AMENDMENT #5

GMHA Invitation for Bid No. 005-2025

New Security Access Control System (ACS) Replacement Project and Preventative Maintenance Services

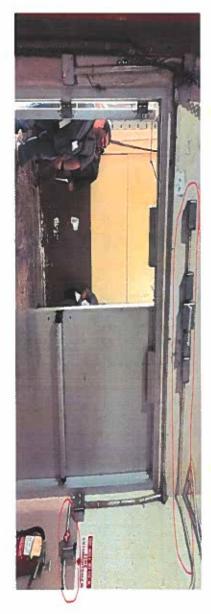
conduit) are ok to use inside the ceiling, since plenum-rated cables meets fire code. My RFI was just to confirm that is ok. During our walkthrough, one of the GMH Staff Member mentioned that Plenum Cables with J-Hooks (no

any exposed cables only. Or conduit for exposed cable and also for the cables inside the ceiling that goes the ACS Panels to the ceiling. So, we don't know if the statement on the IFB Doc. meant conduit to protect all the way to the electrical room. There are some doors with exposed conduit (see image below). The Electrical Room also has conduit from

need conduit the installation will cost a lot less. plenum rated cables? Plenum cables cost more than regular cables, but because you won't For the cables inside the ceiling, is conduit a mandatory requirement? Or are we able to use

the wire runs from the ceiling to their panel box. arrange the wire runs. For those exposed like in the panel rooms you would need to use conduits to secure Yes, Plenum cables may be used without conduits in the ceiling but you would need to use J-Hooks and
